19L ABWR Shutdown Risk Evaluation

The information in this appendix of the reference ABWR DCD, including all subsections, tables, and figures, is incorporated by reference with the following departures.

Figure 19L-3 Potential Path for Draining RPV Through Residual Heat Removal System (Pump On)

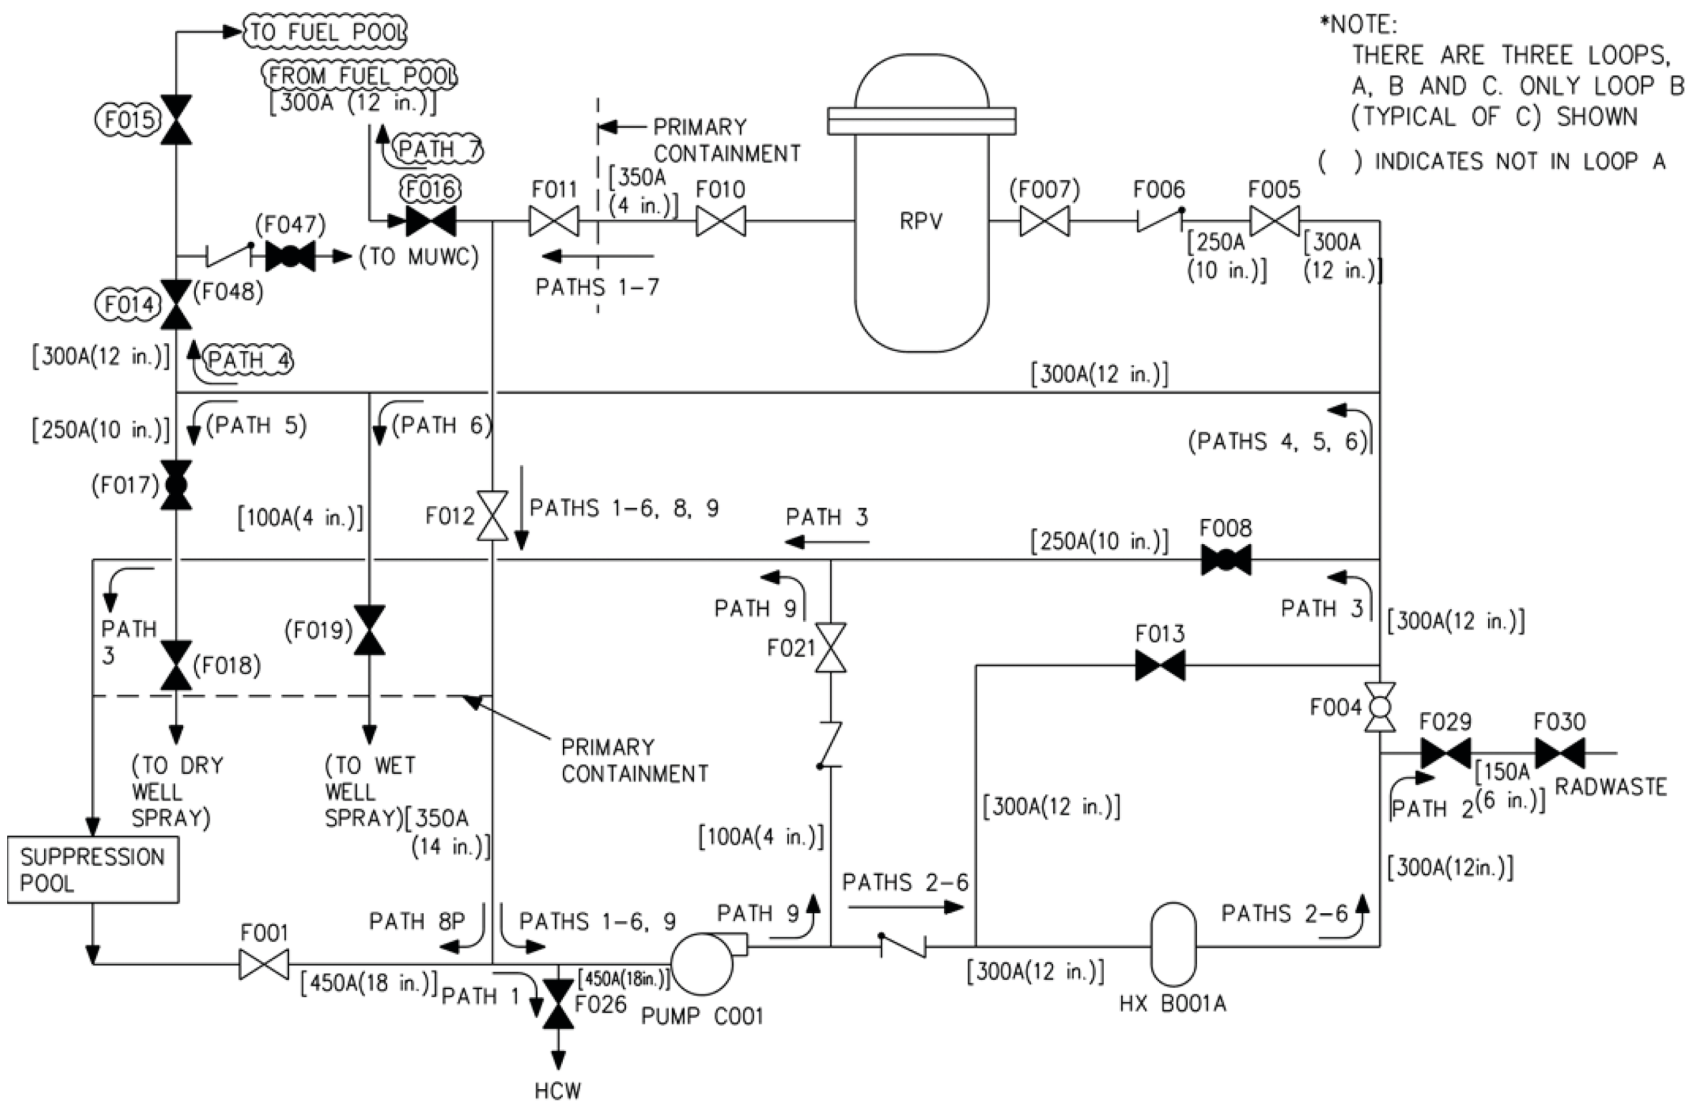
STD DEP T1 2.4-1 (Figure 19L-3)

STD DEP T1 2.4-1 (Figure 19L-3)

STD DEP T1 2.4-1

The residual heat removal (RHR) design will have three RHR loops connected to the fuel pool cooling and cleanup system (FPCCS) instead of two for the reference ABWR DCD with normally closed inter-ties to permit additional supplemental cooling during refueling outages to reduce outage time.

Increasing the number of RHR loops connected to FPCCS from two to three results in a decrease in CDF, because it is an improvement of the outage management control for the fuel pool cooling system.
